**DEFENSE NUCLEAR FACILITIES  
SAFETY BOARD**

February 12, 2024

## Staff Report

### Review of the Pantex Plant Fire Protection Program

**Figure 1.** Comparison of Short-Term and Long-Term Impairments

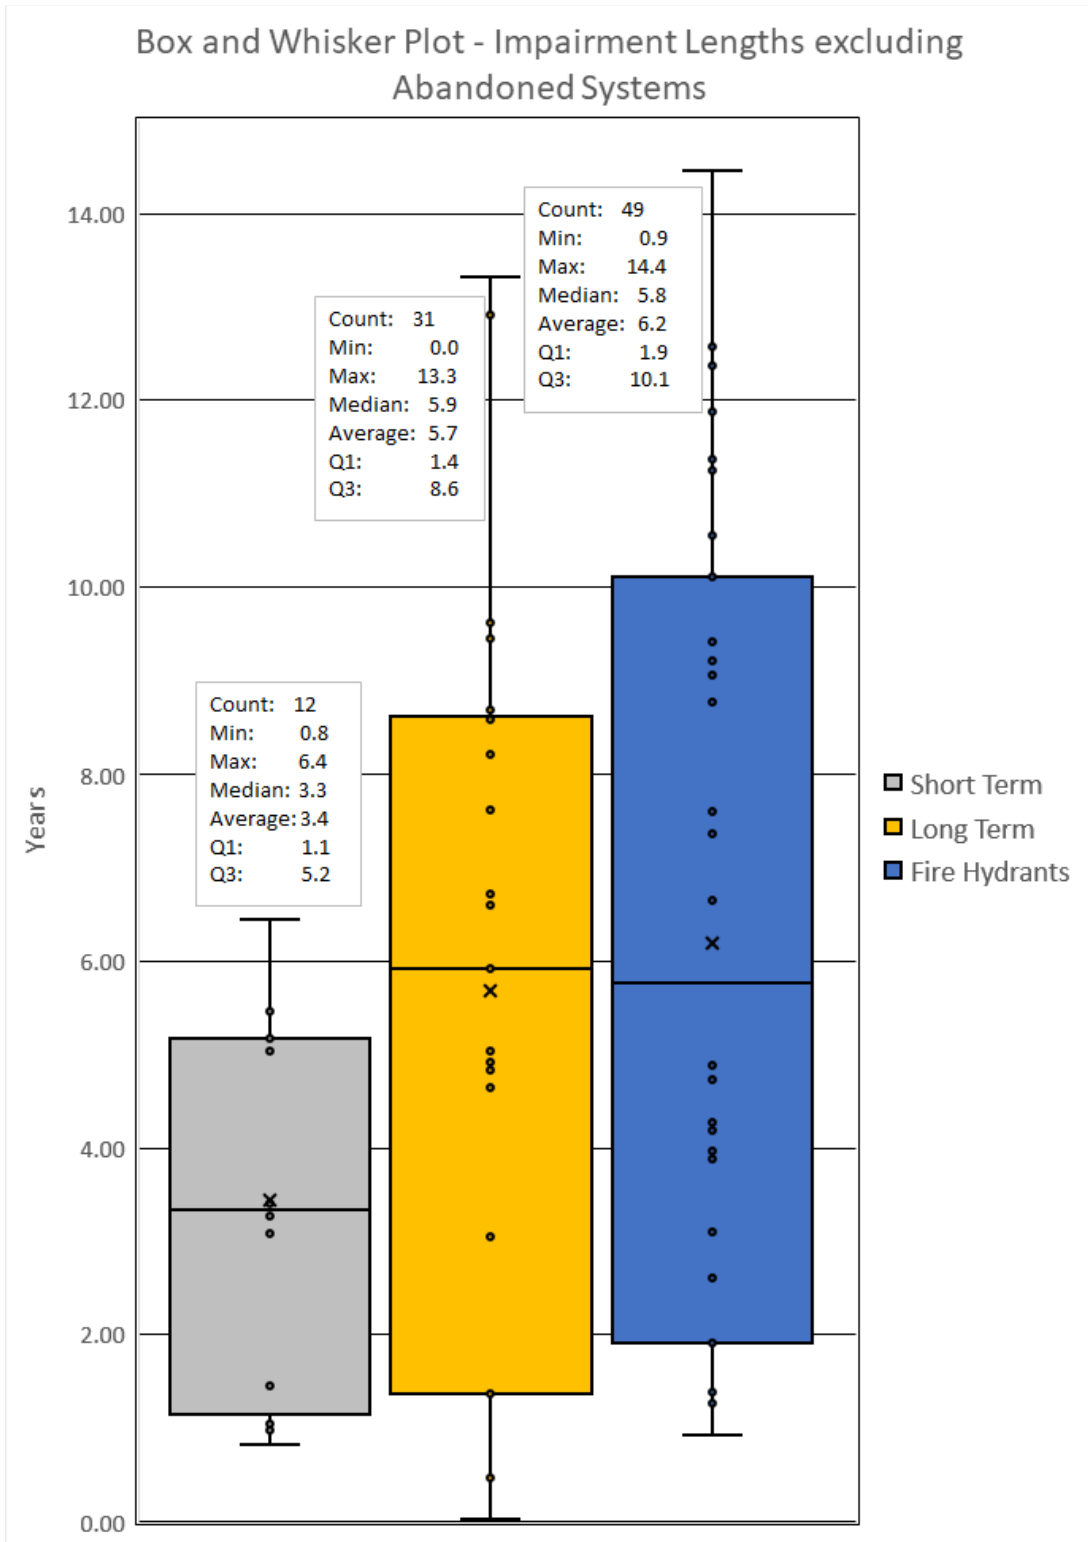
In addition to delays in notifying ESDC, the current impairment data categorization is not conducive to prioritize repairs. For example, there is little differentiation between short-term and long-term impairments, which can be used as a part of prioritization. Figure 1 shows the length of impairments in the short-term, long-term, and fire hydrant categories from Pantex impairment data. As seen in Figure 1, there is significant overlap in the length of impairments considered "short-term" and "long-term." The fire hydrant category in the figure demonstrates that these impairments could be considered either short- or long-term.

Poor categorization of impairments can hamper proper prioritization of repairs to impaired systems. CNS stated that a part of the new effort to track impairments will include redefining what constitutes a short- or long-term impairment, as well as additional categorization. CNS has already made some improvements to impairment data categorization, such as removing abandoned systems from the long-term category. The staff review team agrees with this approach and considers that additional study of impairment data categorization could further improve prioritization of repairs.

**Figure 2.** *Categorization of Preventive Maintenance in Monthly Metric Report [2]*

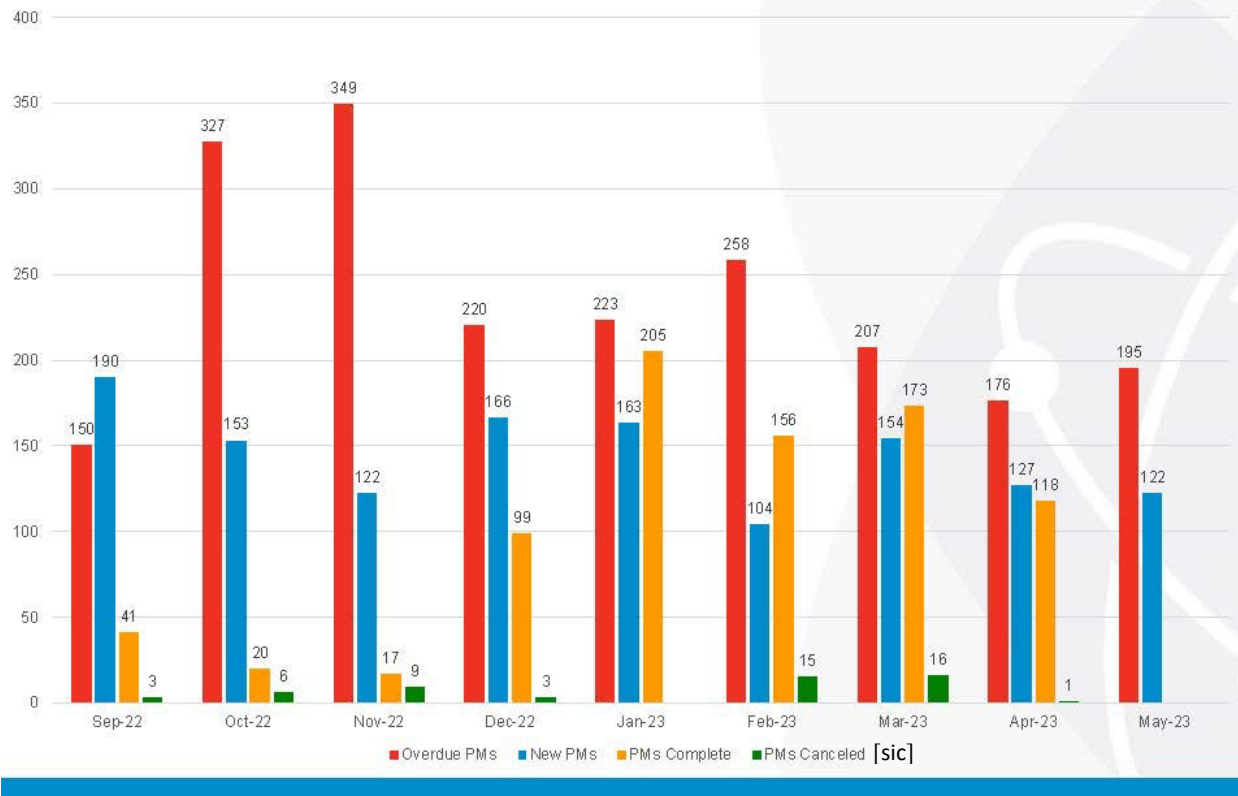
*Confusing Presentation of Metrics for Preventive Maintenance (PM)*—The monthly report of fire protection metrics notes fire system PM activity in terms of “Overdue PMs,” “New PMs,” “Completed PMs,” and “Cancelled PMs.” Figure 2 shows an example of the presentation of monthly PM metrics.

As suggested by the category title “Cancelled PMs,” it appears that CNS cancelled fire protection maintenance activities on a regular basis. CNS clarified that the category of “Cancelled PMs” in the Pantex site fire protection maintenance data consists of two subcategories:

CNS stated that most, if not all, “Cancelled PMs” fall into the first category, and that no systems in defense nuclear facilities fell into the second category. While the staff review team now understands this nuance, CNS should consider revising the presentation of PM data in the monthly metric report to more clearly depict how many PMs are cancelled and not performed.
